**THE CITY OF KEY WEST**  
1300 White St  
Key West, FL 33040

**ADDENDUM NO. 1**  
**ITB 23-019**  
**Replace KWPD Flooring**

Project  
**PUBLIC SAFETY FACILITY  
PHASE II - POLICE STATION**  
KCO West, Florida  
Sheet Title  
FOUNDATION AND  
FIRST FLOOR  
FRAMING PLAN

**FOUNDATION & FIRST FLOOR FRAMING PLAN**  
VP-4-0 True North Point North

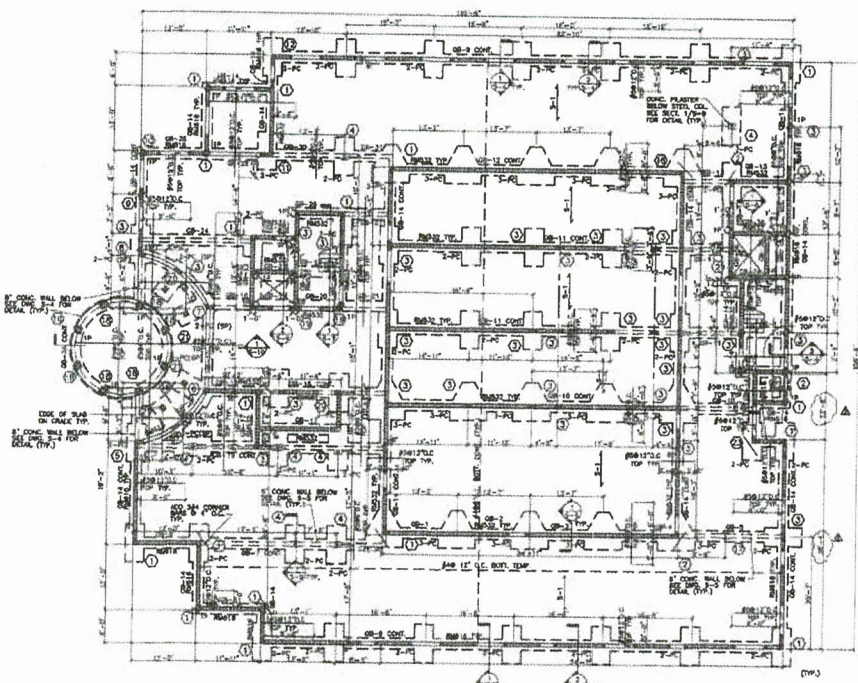
- 1. 6mil visqueen moisture barrier with 6" overlap on seams required on the first floor. Moisture barrier is not required on the second floor.**
- 2. Room 107 will not be a part of the project.**
- 3. Cabinets in Room 123 will be moved.**
- 4. The floorplan is attached to this Addendum.**
- 5. Slip under transition strip in doorways meeting ADA requirements.**
